SALEM NUCLEAR GENERATING STATION, UNIT NO. 2

AMENDMENT TO FACILITY OPERATING LICENSE

Amendment No. 129
License No. DPR-75

ATTACHMENT TO LICENSE AMENDMENT NO. 129

Figure 3.4-2

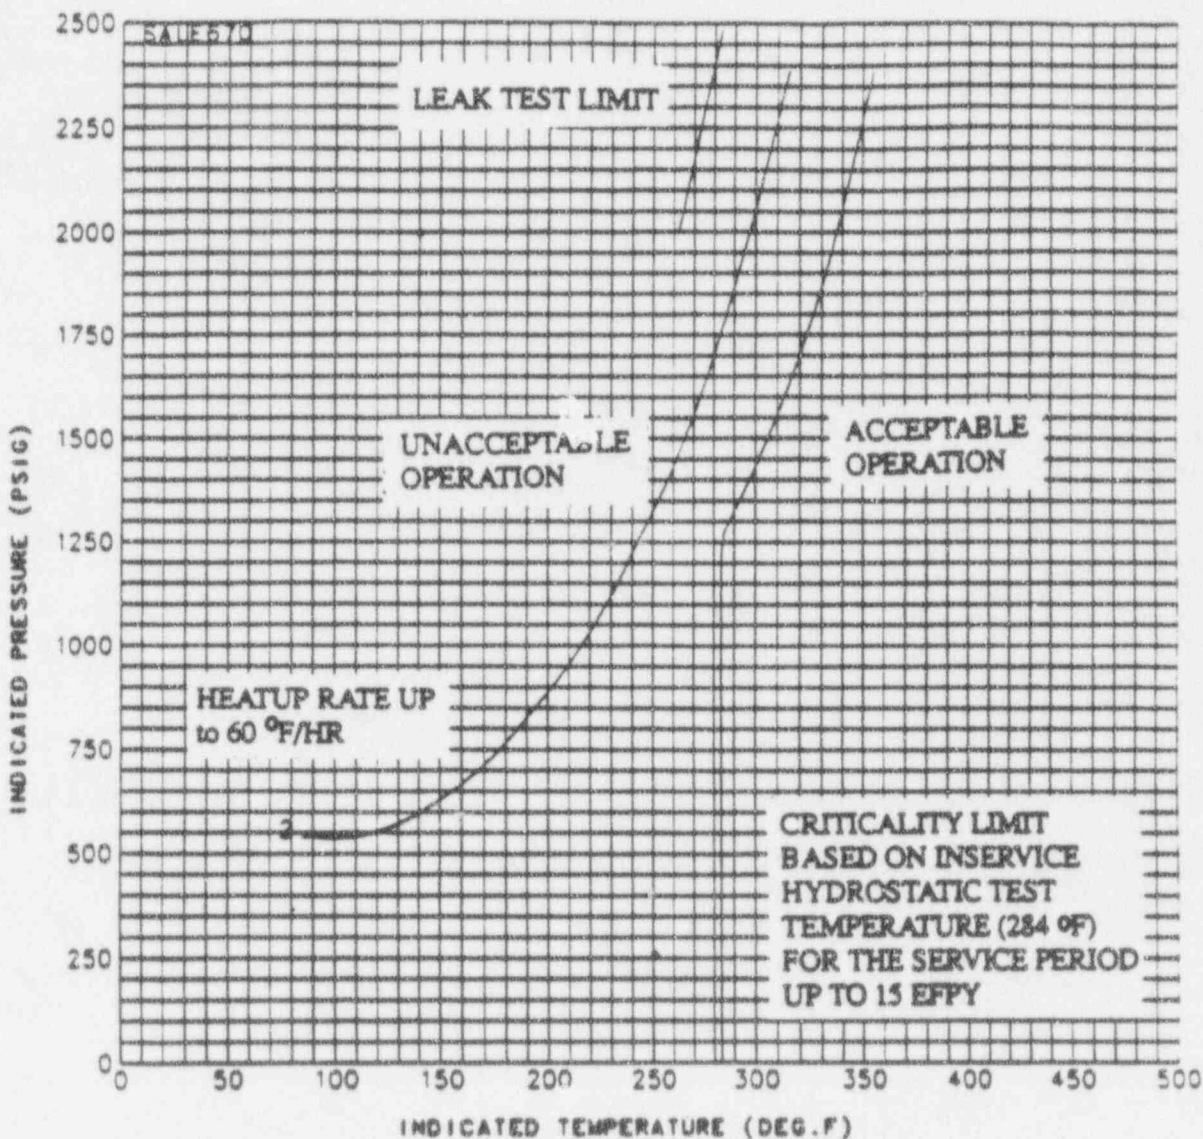
LIMITING ART AFTER 15 EFPY: 1/4T, 151°F
 3/4T, 102°F

SALEM UNIT 2 REACTOR COOLANT SYSTEM HEATUP LIMITATIONS APPLICABLE FOR THE FIRST 15 EFPY WITH MAXIMUM HEATUP RATE OF 60 F/HR. CURVE CONTAINS NO MARGIN FOR INSTRUMENT ERRORS.

Figure 3.4-3

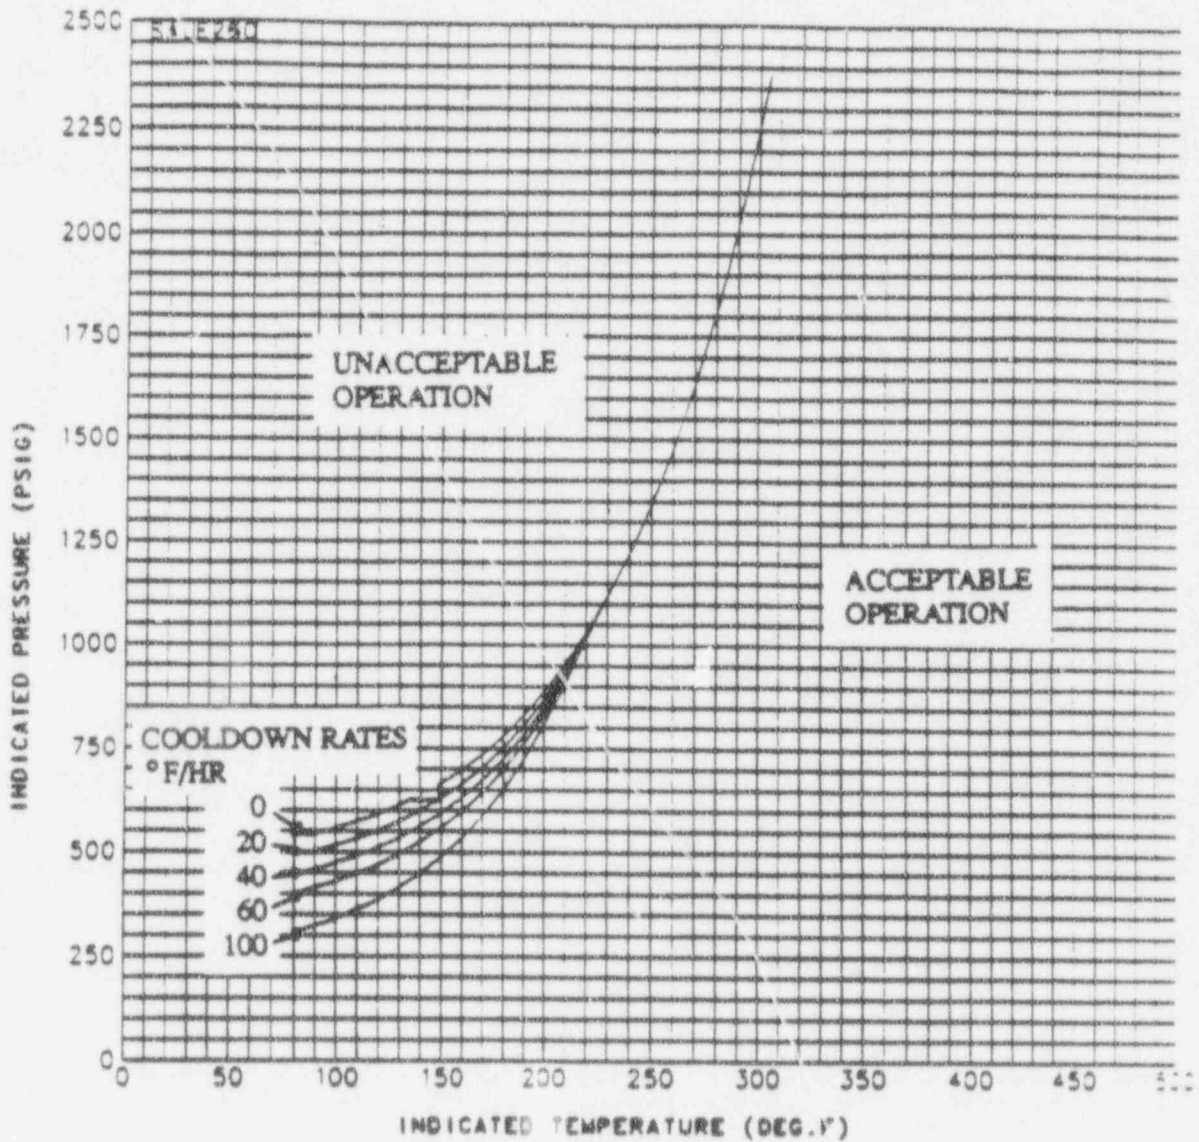
LIMITING ART AFTER 15 EFPY: 1/4T, 151°F
3/4T, 102°F

SALEM UNIT 2 REACTOR COOLANT SYSTEM COOLDOWN LIMITATIONS APPLICABLE FOR THE FIRST 15 EFPY WITH MAXIMUM COOLDOWN RATE OF 100 F/HR. CURVE CONTAINS NO MARGIN FOR INSTRUMENT ERRORS.
